SUBJECT: Explanation of Significant Differences for the Hooker Hyde Park Superfund Site

## **Explanation of Significant Differences**

### **Hooker Hyde Park Landfill Town of Niagara, Niagara County, New York**

**May 2012**

figure 1  
SITE LOCATIONS  
HYDE PARK BOULEVARD  
*Niagara Falls, New York*

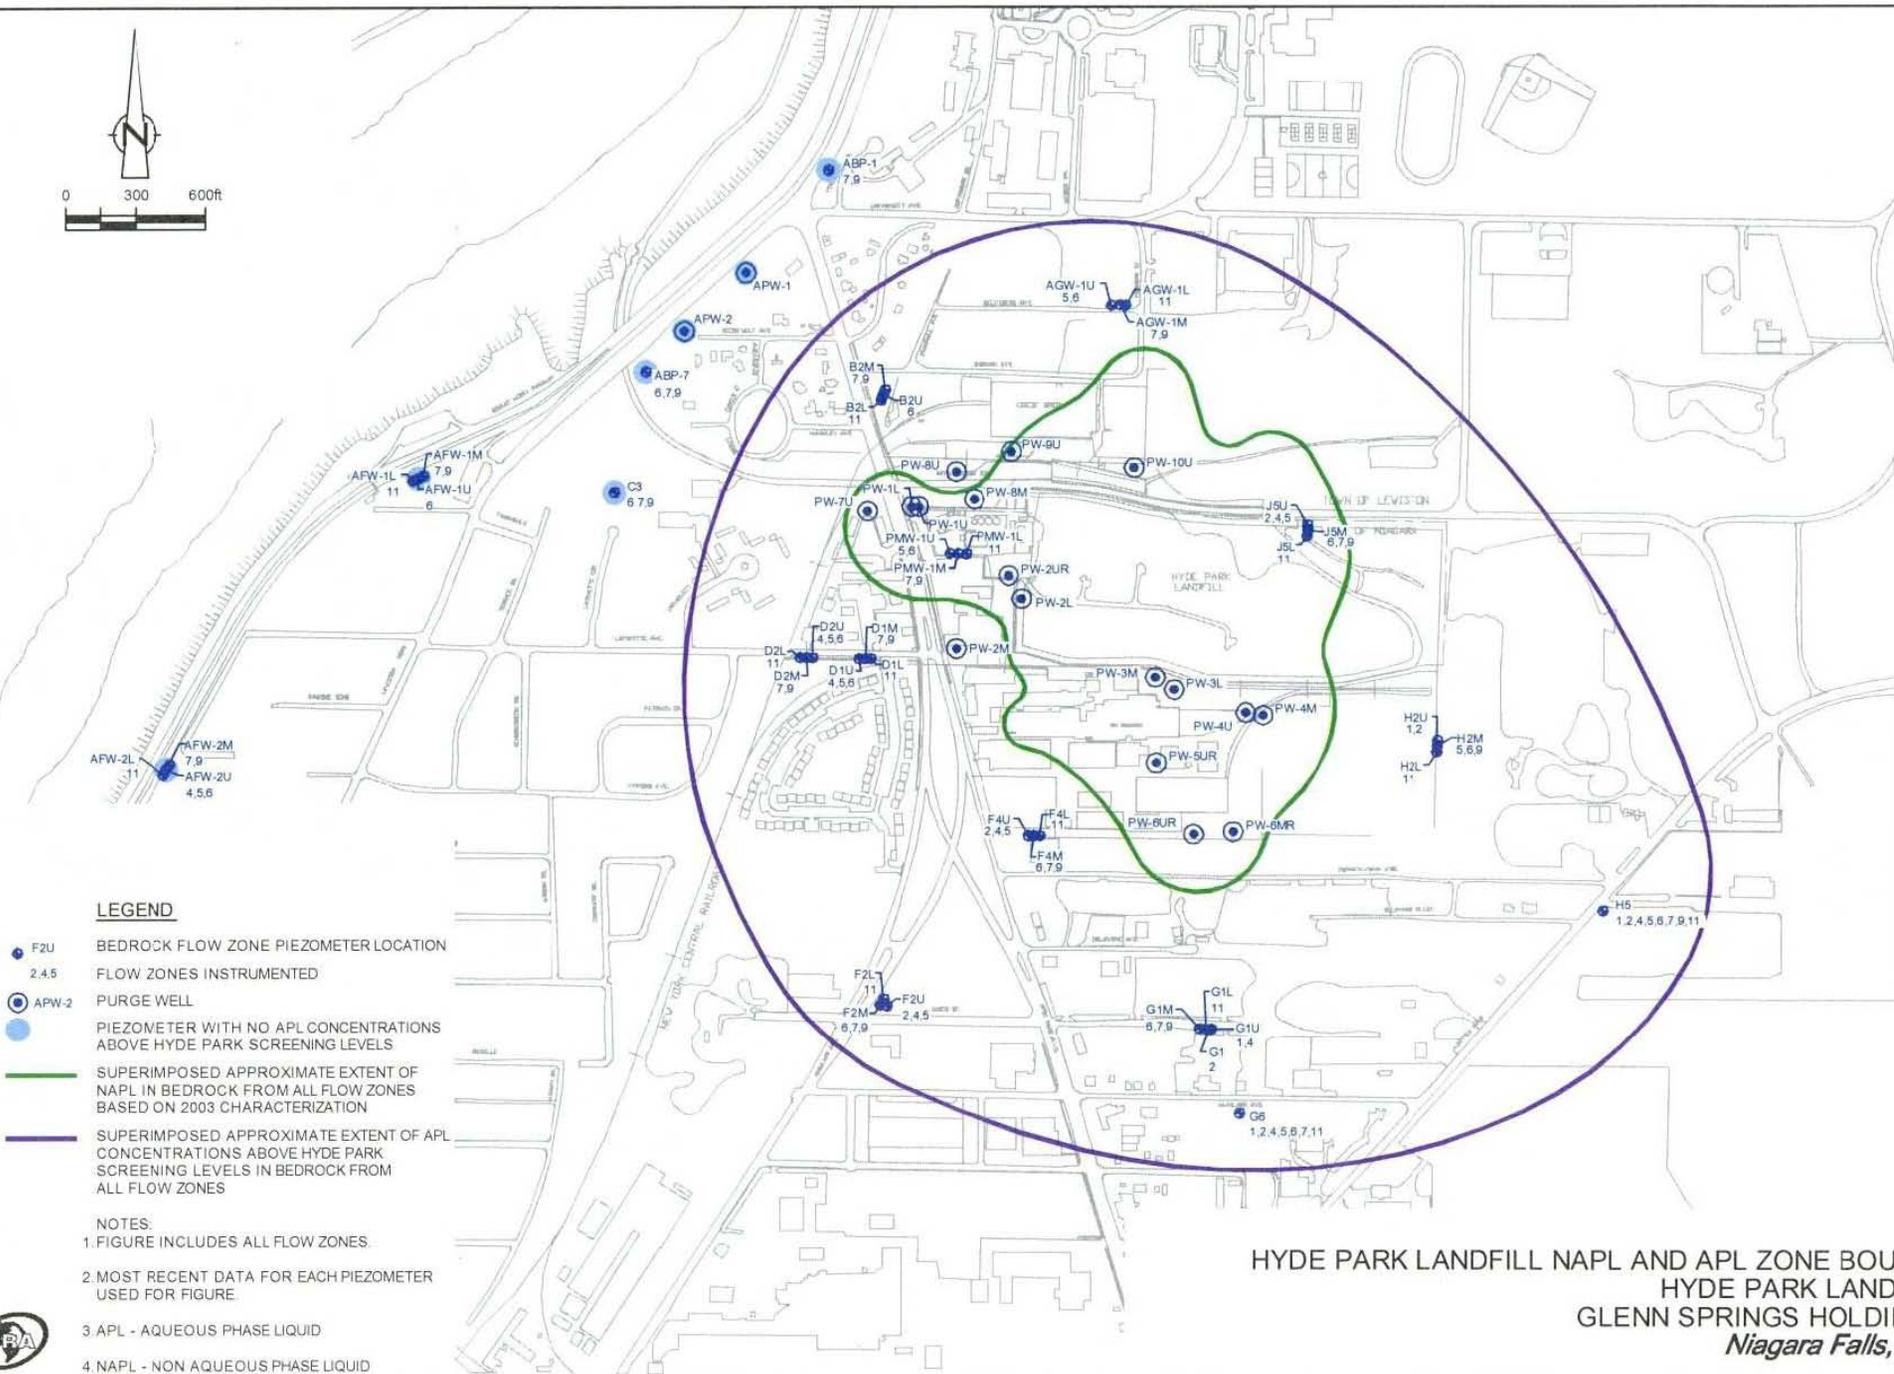
The EDD did not specify the implementation of institutional controls as a component of the selected remedy. A Declaration of Restrictive Covenants and Environmental Easement was placed on the deed to the Landfill property at the County recording office in Niagara County on October 7, 2010. The Grantor (OCC) grants a permanent restrictive covenant and an environmental easement to the Grantee (Town of Niagara) to provide a right of access over the approximately twenty-one acre property (the "Property") for purposes of implementing, facilitating, and monitoring the remedial action. The covenant/easement also imposes on the Property certain use restrictions that will run with the land for the purpose of protecting human health and the environment in the future. Figure 1 identifies the boundaries of the environmental easement.
